# Facility-Wide GW Monitoring Plan (FWGWMP)

RE: DISAPPROVAL FACILITY-WIDE GROUND WATER MONITORING WORK PLAN, 2011 UPDATES WESTERN REFINING COMPANY SOUTHWEST INC., GALLUP REFINERY EPA ID # NMD000333211 HWB-WRG-12-002

The New Mexico Environment Department (NMED) has reviewed the *Facility-Wide Ground Water Monitoring Work Plan, 2011 Updates* (Work Plan), dated March 2012, submitted on behalf of Western Refining Company Southwest Inc., Gallup Refinery (Permittee) and hereby issues this notice of disapproval.

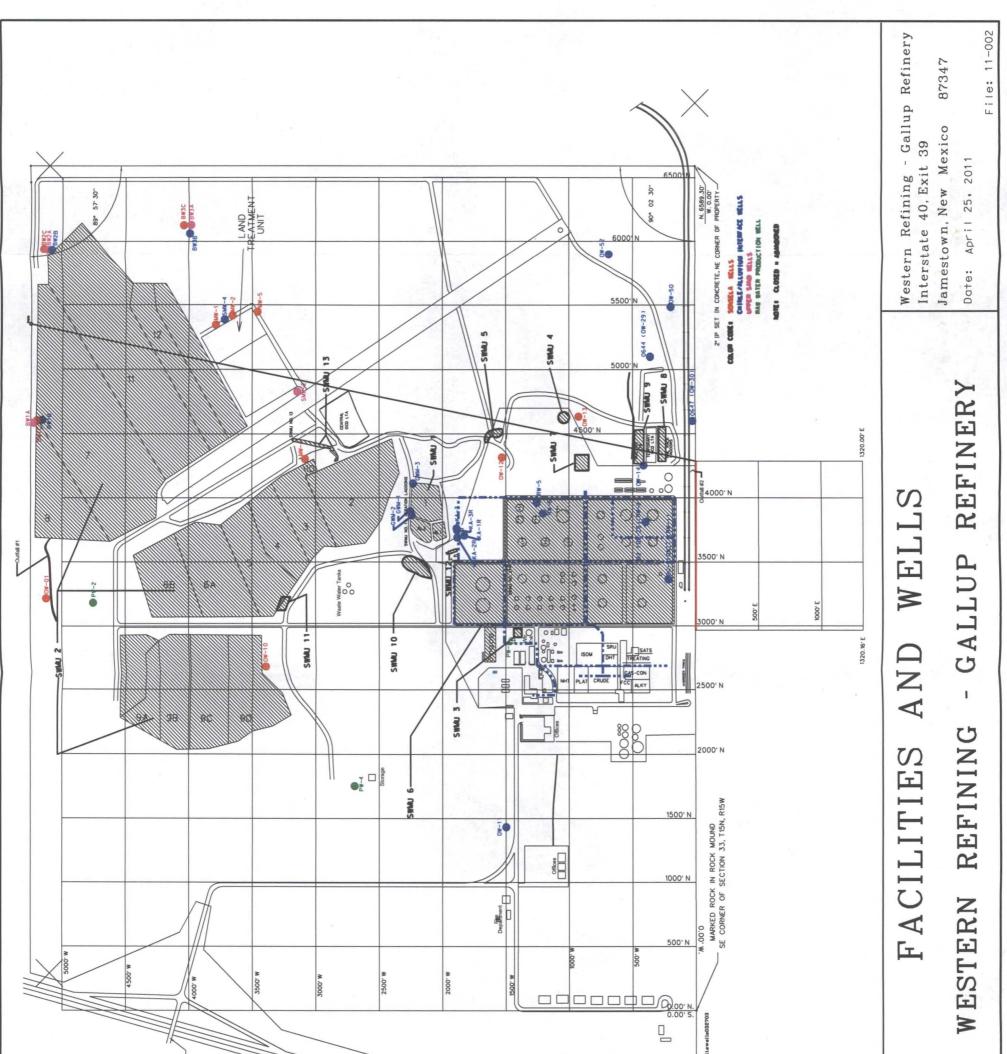
There are several issues regarding the figures included in the Work Plan. Figure 3, Figure 5 and 5b are difficult to read. Remove the hatching over the SWMUs in Figure 3. Increase the font size or do not bold the groundwater monitoring well labels so that they are legible. On Figure 5 remove the closed (abandoned) wells. The NAPIS wells are mis-labeled as KA-wells on all three figures; re-label them appropriately. Ensure that the figures include all of the groundwater monitoring and recovery wells. Use the same base map showing all groundwater and recovery wells for all of the figures. On Figures 5 and 5b, include the groundwater elevations along with

the groundwater monitoring well designation labels so that the elevations and groundwater contours can be verified. Report the dates that the groundwater data were collected in the map legend. Revise the figures as needed.
